WJ 8617B and 8618B 10 KHz IF Bandwidth Upgrade

By: Stephen Pappin

This procedure focuses on the modification of 20 KHz IF Amplifier and FM Demodulator boards.

Figure 5-19. Type 724006 21.4 MHz IF Amplifier (A3A9-A3A13), Location of Components

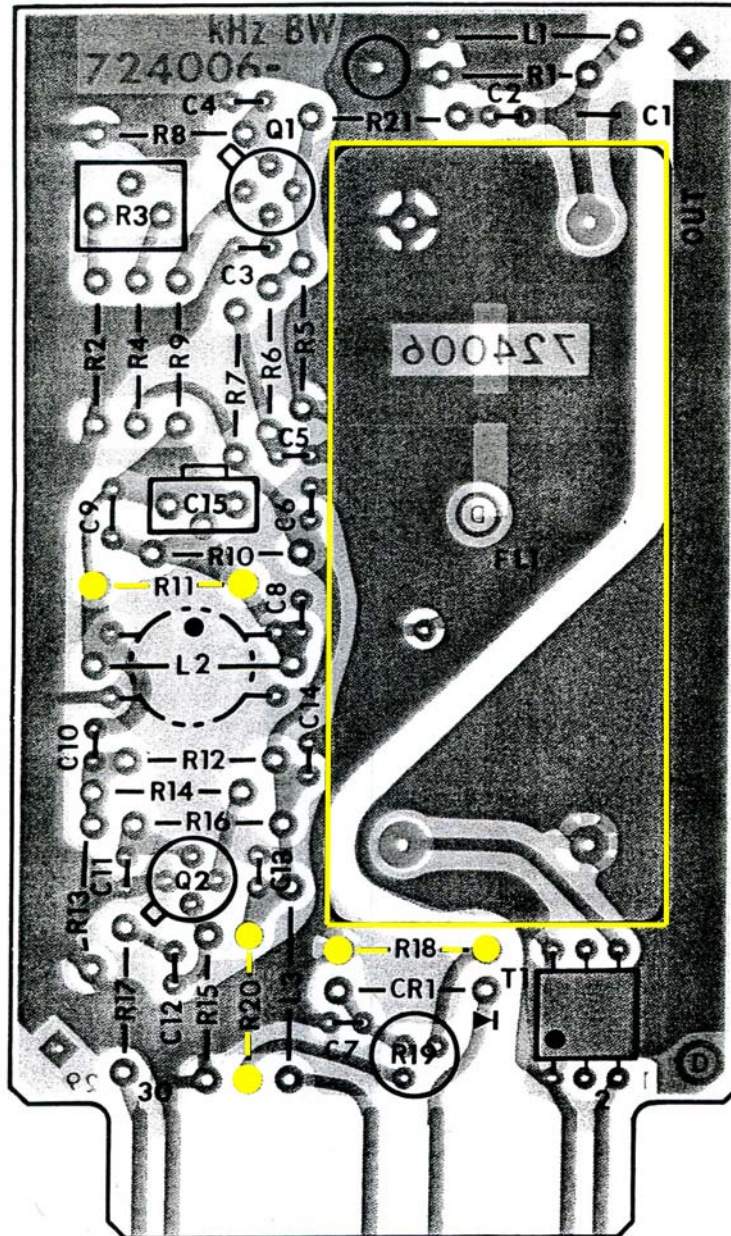
Remove R11

Replace R18 with a 100 Ohm resistor

Replace R20 with a 3.3K Ohm resistor

Replace the 20 KHz filter can p/n 92002 with the 10 KHz filter can p/n 92001

Change the board designation to -1

Figure 5-26. Type 794106 FM Demodulator (A3A17-A3A21), Location of Components

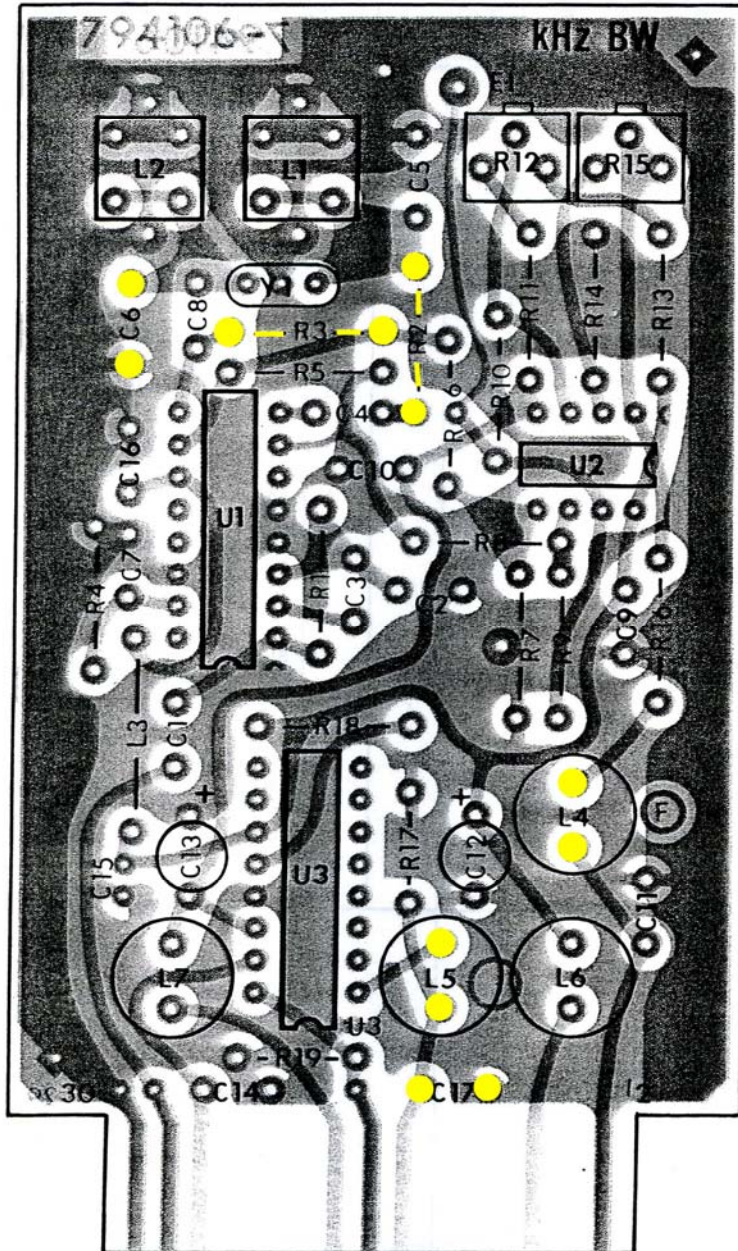
Replace L4 with a 22mH inductor

Replace L5 with a 15mH inductor

Replace C6 with a silver mica or ceramic capacitor

Replace C17 with a 0.068uF film or molded ceramic capacitor

Replace R2 with a 2.37K Ohm, 1/10 W, metal film resistor

Replace R3 with a 1.37K Ohm, 1/10 W, metal film resistor

Change the board designation to -1
